UNITED STATES PATENT AND TRADEMARK OFFICE

Office Action Summary

10/538,829

DETAILED ACTION

Fig. 1 from Mason

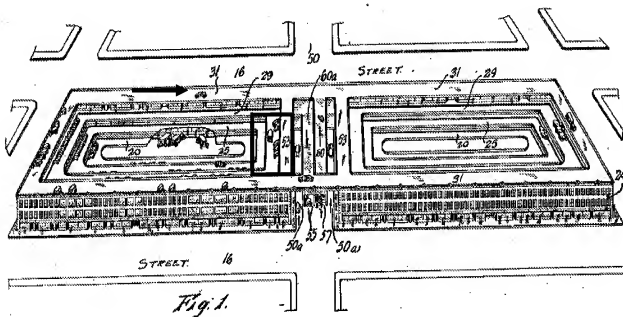
Regarding claim 1, Mason discloses a "mixed-use pedestrian parking structure (Fig. 1 in general) comprising:

- (a) at least two sequential multi-level parking units (Fig. 1, right and left buildings separated by intermediate street 50), each having one directional parking access aisle[s] (Fig. 1, element 25);
- (b) a liner building surrounding [the] parking units on at least one side of each of [the] sequential multi-level parking unit[s] (Fig. 2, elements 35, 18, 22, 27; page 4, lines 9-10 and 15-16); and
- (c) a multi-use buffer corridor (Fig. 2, element 36) defining an interface (Fig. 2, element 37) between [the] parking units (Fig. 2, element 25) and [the] liner building (Fig. 2, elements 35, [the] liner building including at least one common wall (interior wall 28) with [the] buffer corridor, [the] wall including means for access to and from [the] buffer corridor (page 4, line 67 defines names element 36 as a passageway; page 4 lines 39-42)."

Regarding claim 4, Mason discloses “an interior pedestrian corridor, transverse to [the] exterior corridor, [the] interior corridor substantially bisecting [the] at least two parking units (Fig. 1, portion of element 21 parallel with street 50).

Regarding claims 5 and 6, Mason discloses “a central atrium within at least one of [the] parking units (Fig. 1, right and left parking units have an open air atrium by nature of their inverted-pyramid design at the bottom of which lies parking/roadway 20).”

Regarding claim 11, Mason discloses a “mixed-use pedestrian parking structure (Fig. 1 in general) comprising:

(a) at least two multi-level parking units (Fig. 1, right and left buildings separated by intermediate street 50), each having one directional parking access aisle[s] (Fig. 1, element 25);

Regarding claim 14, "an interior pedestrian corridor, transverse to [the] exterior corridor, [the] interior corridor substantially bisecting [the] at least two parking units (Fig. 1, portion of element 21 parallel with street 50).

Regarding claim 15, Mason discloses "a central atrium provided within the parking units (Fig. 1, right and left parking units have an open air atrium by nature of their inverted-pyramid design at the bottom of which lies parking/roadway 20)."

Regarding claim 19, Mason discloses "a cross-over ramp between [the] sequential parking units" (Fig. 1, element 53/31 on top level)."
